BALTIMORE GAS AND ELECTRIC COMPANY
DISTRIBUTION
SERVICES UNIT
P.O. BOX 1475
BALTIMORE, MARYLAND 21203

SUBJECT: Calvert Cliffs Nuclear Power Plant
Unit No. 1, Docket No. 50-317
Amendment to Operating License DPR-53
Fifth Cycle License Application
Responses to NRC Staff Questions

QUESTION 1X

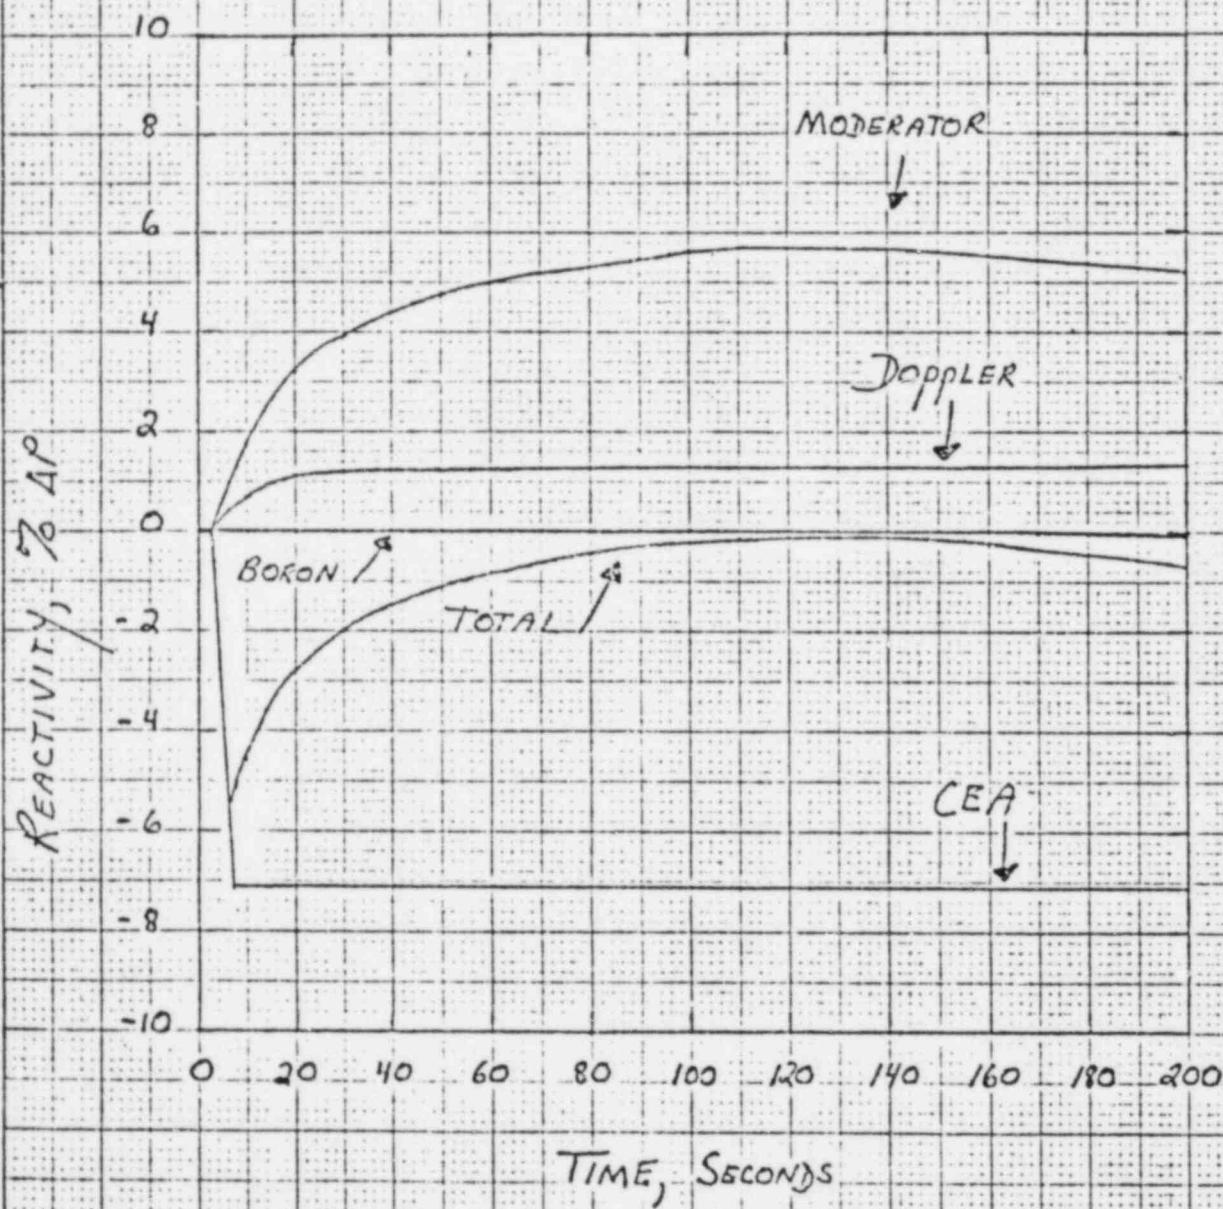
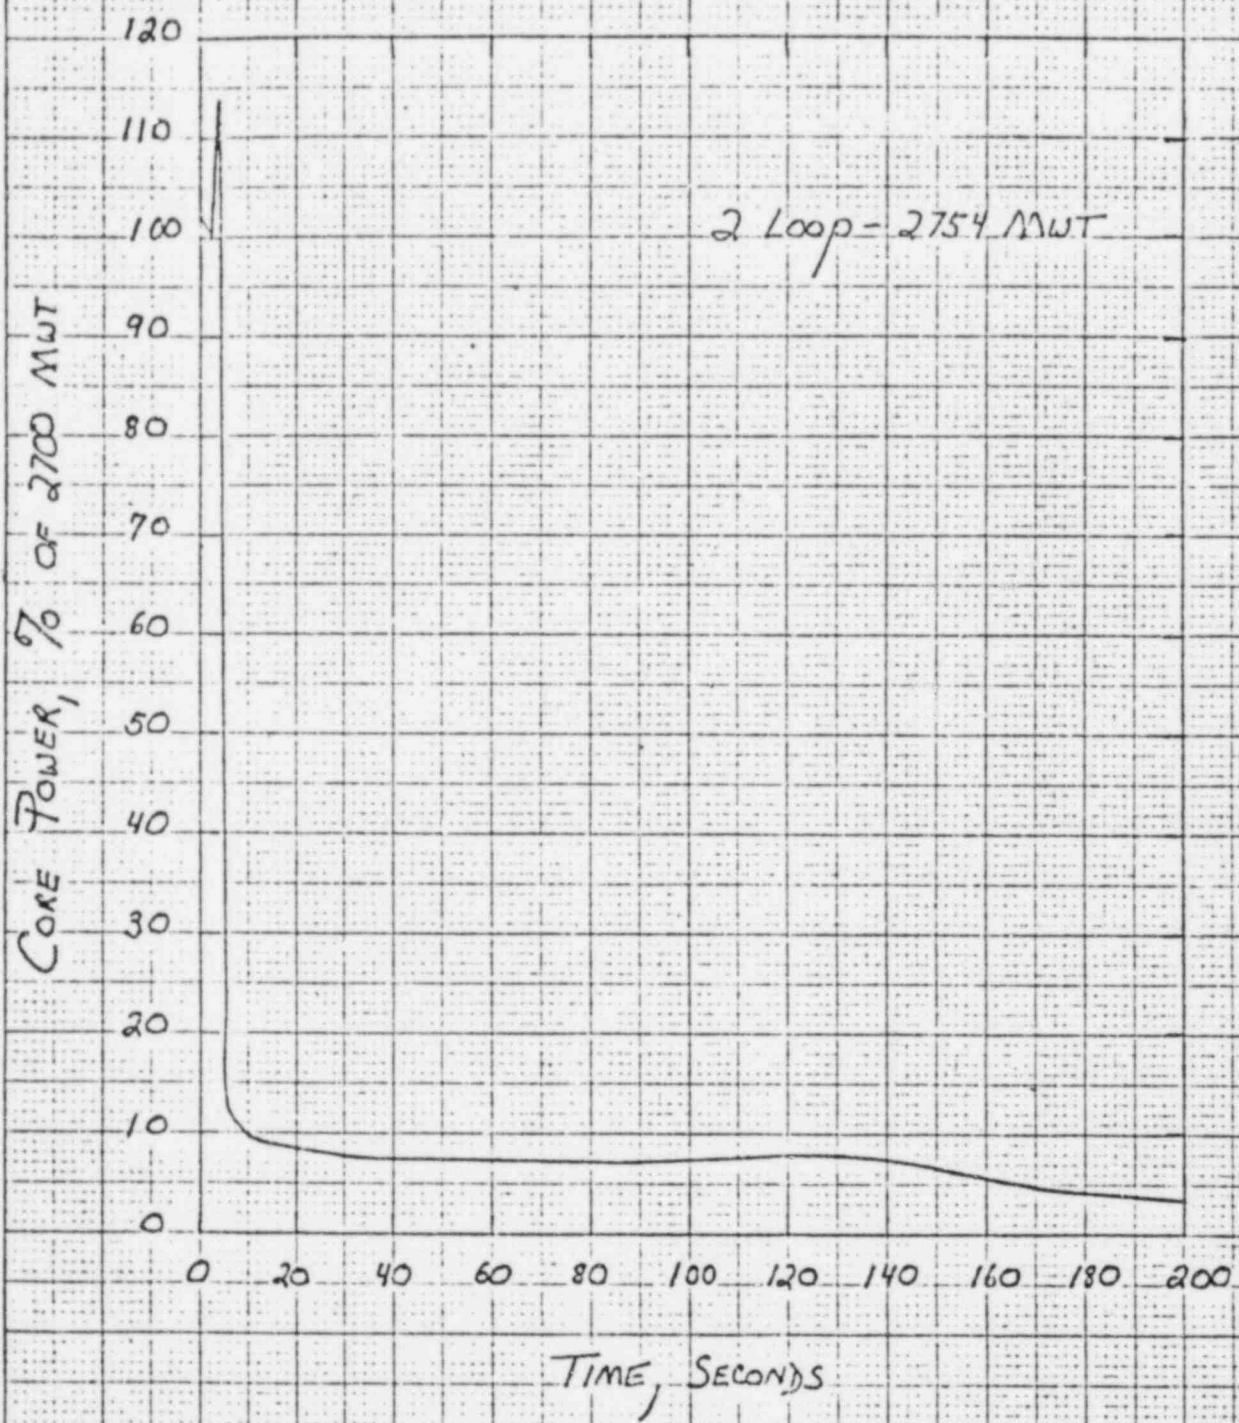
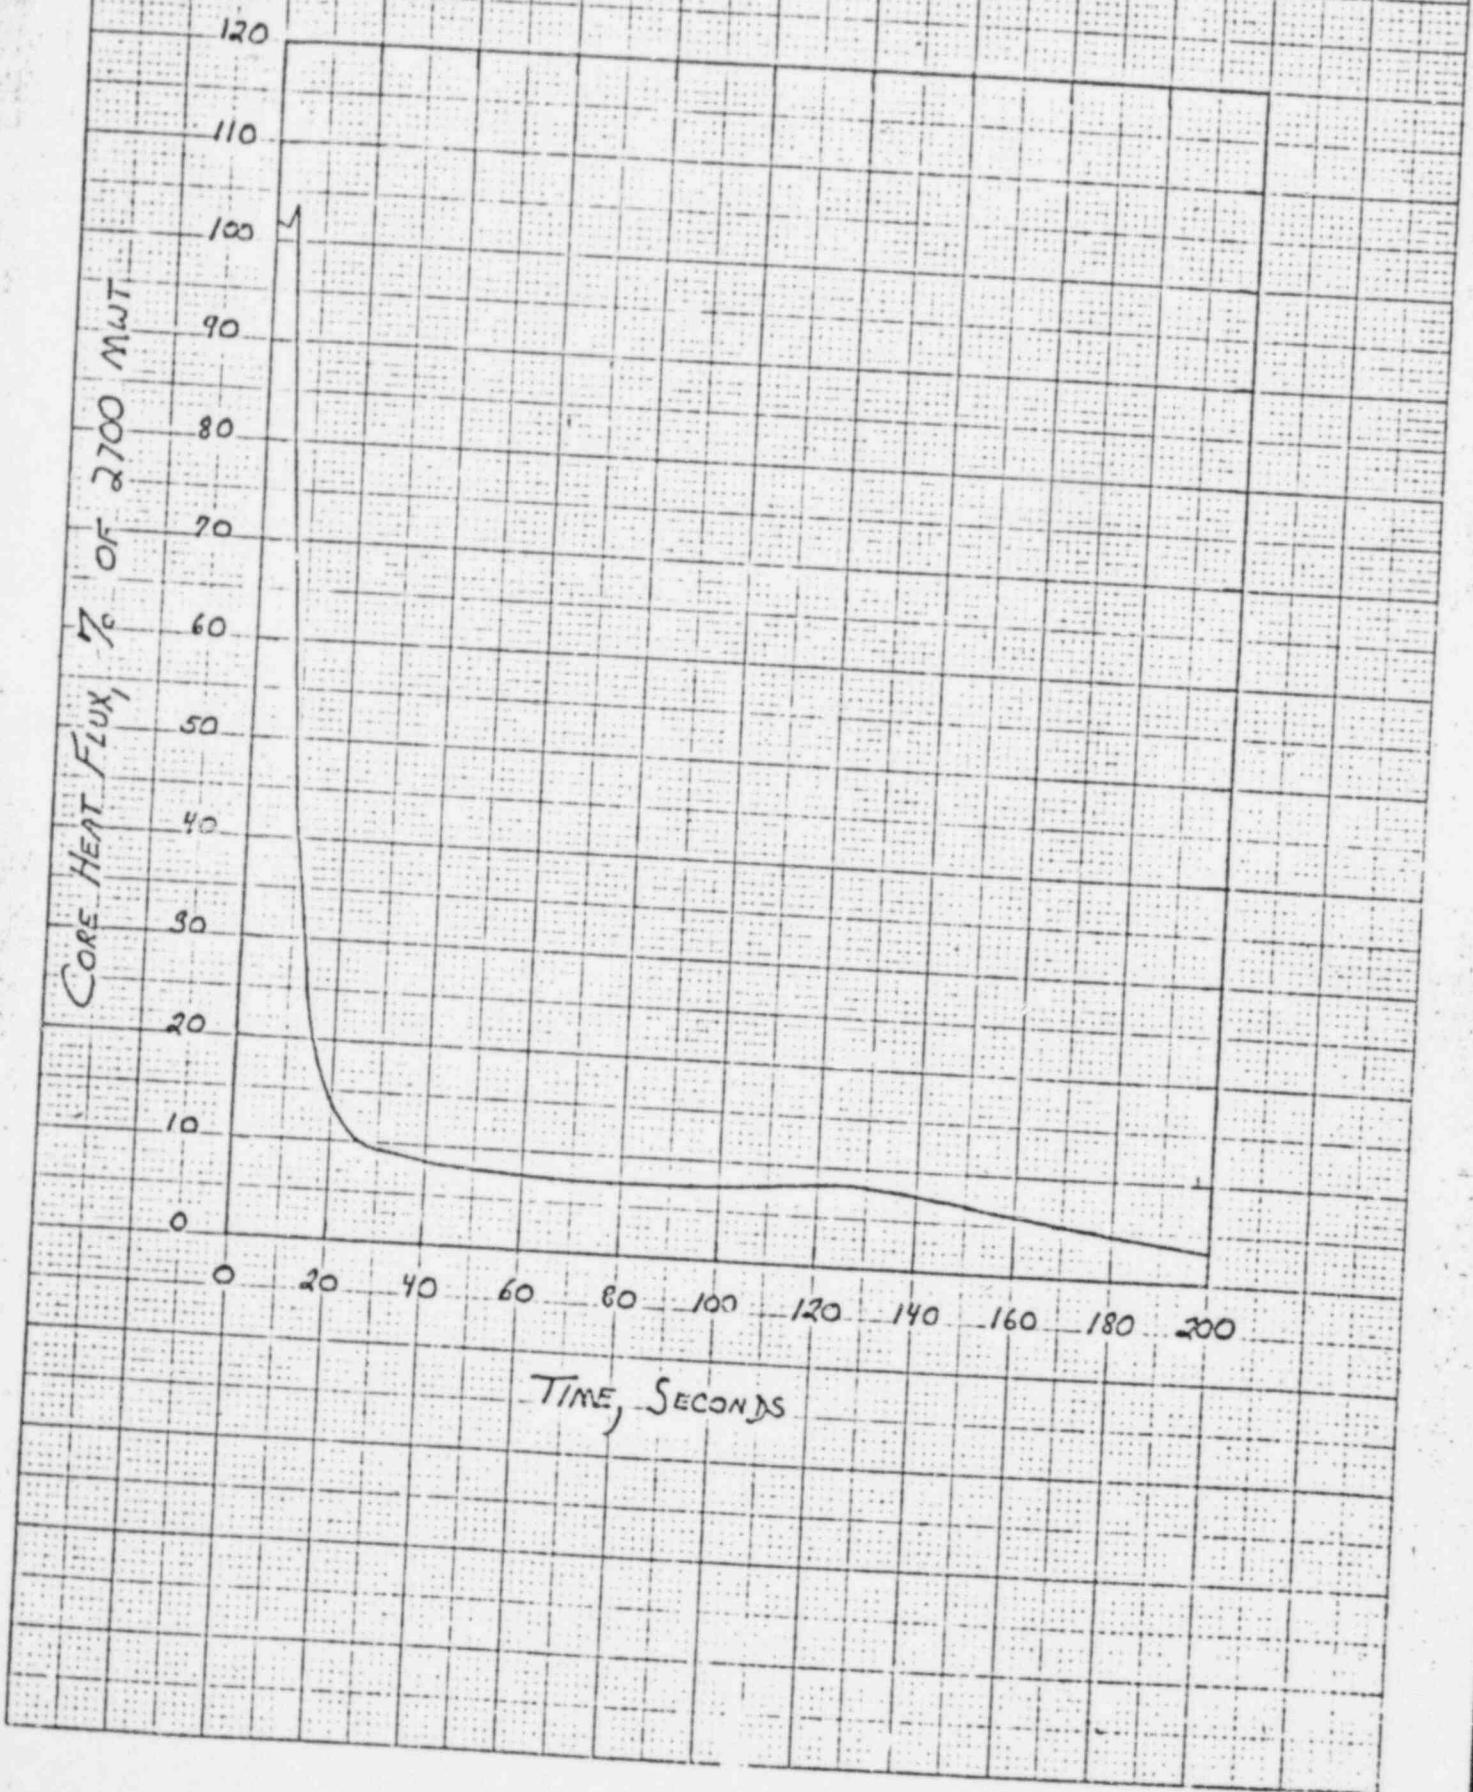
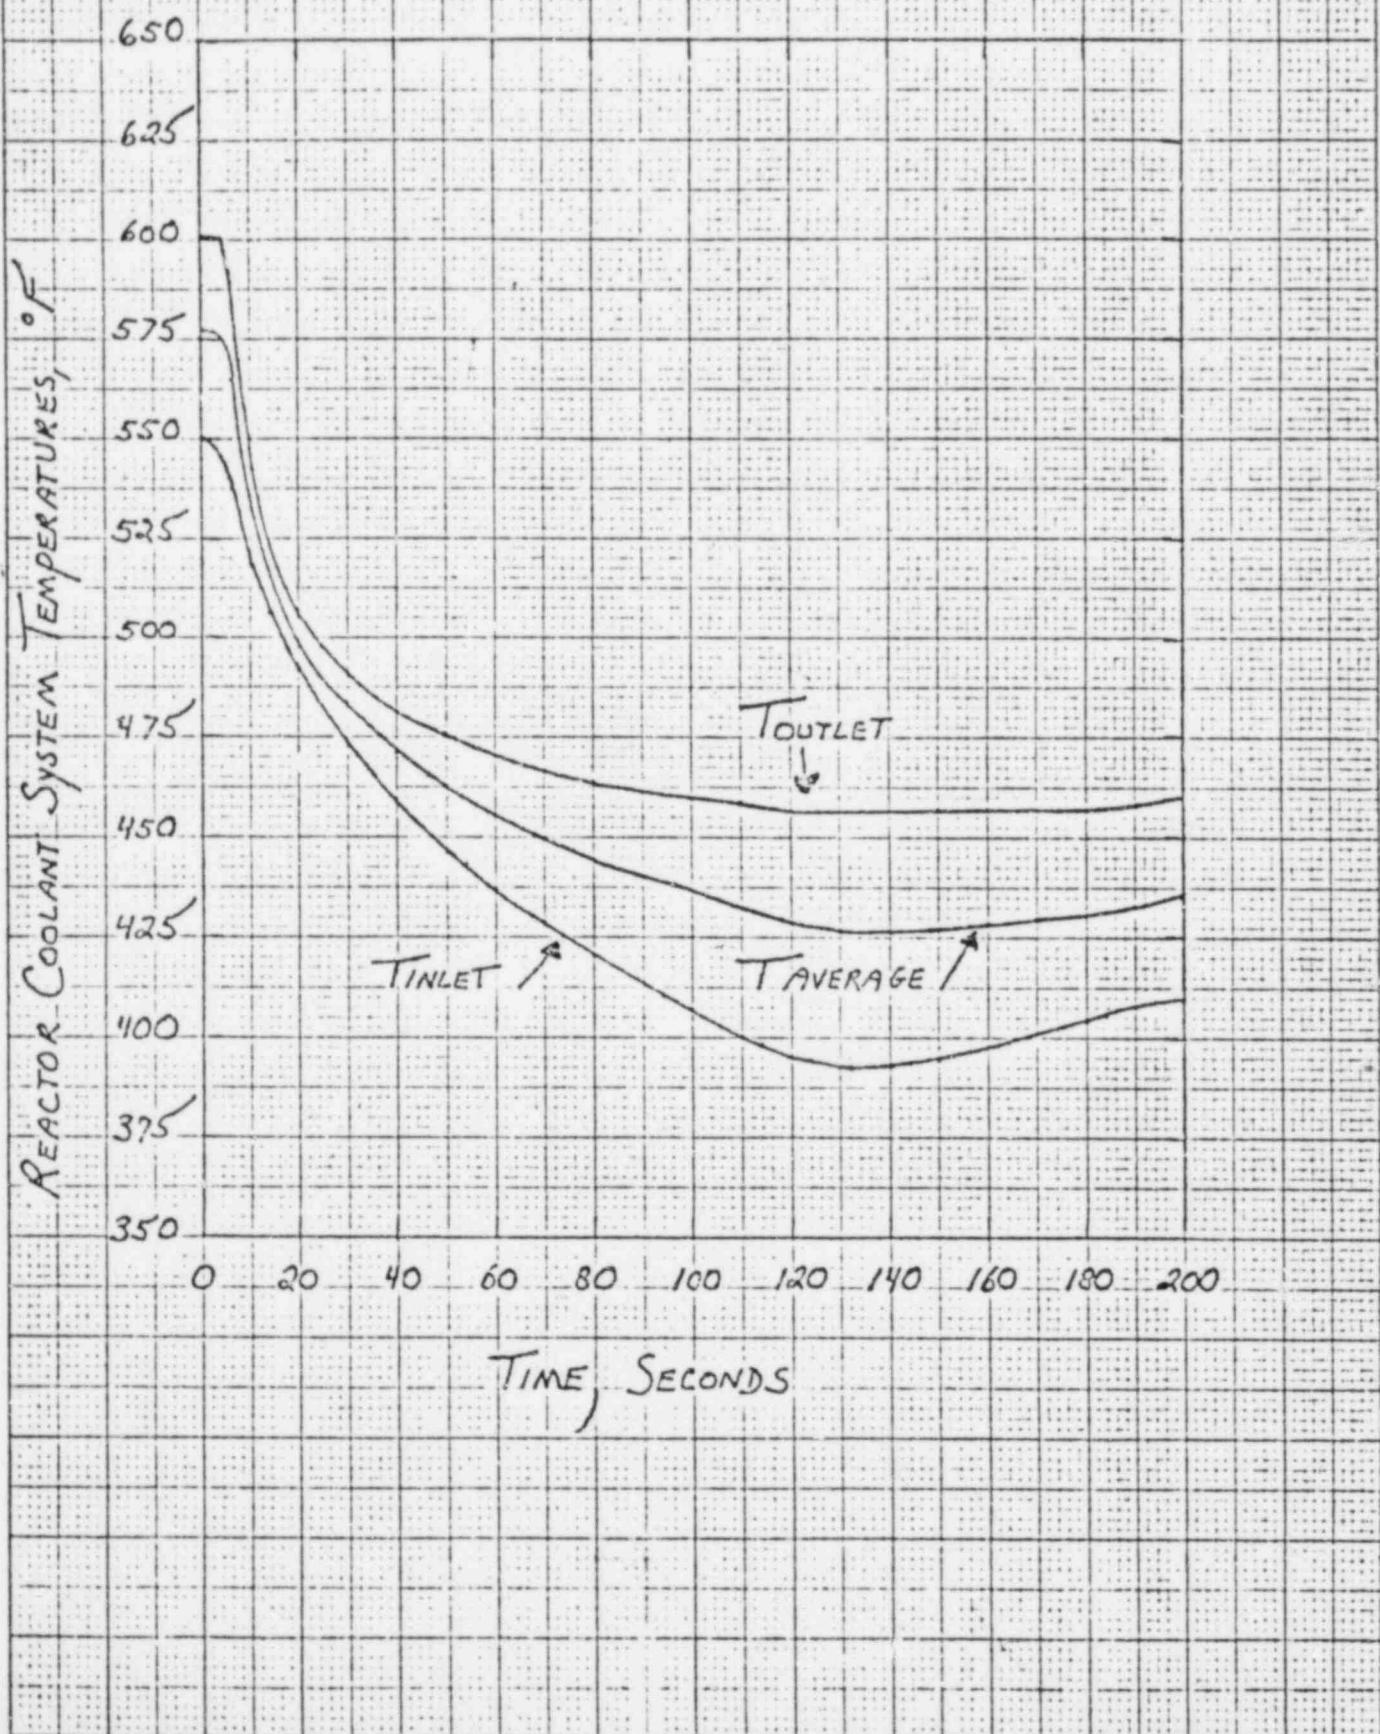
Provide comparative Steam Line Break analyses between CESEC-SLB and old version of CESEC. The comparison should include the following cases:

- a. CESEC-SLB with pumps off
- b. CESEC-SLB with pumps on
- c. old CESEC version with pumps off
- d. old CESEC version with pumps on.

Figures 1X-1 to 1X-5 present the NSSS response during a SLB event with RCP's off using the version of CESEC named CESEC-SLB.

1. The SLB event with RCP's off, analyzed with code version CESEC-SLB, determines the moderator reactivity feedback based on the cold edge inlet temperature. For all other SLB events presented the moderator reactivity feedback is calculated using the core average moderator temperature.

4. The limiting SLB event is with the RCP's off analyzed using the code version CESEC-SLB. This event is presented in the Calvert Cliffs Unit 1, Cycle 5 license submittal (Reference 1X-3).

5. The minimum DNBR for the limiting SLB event is greater than 1.6.
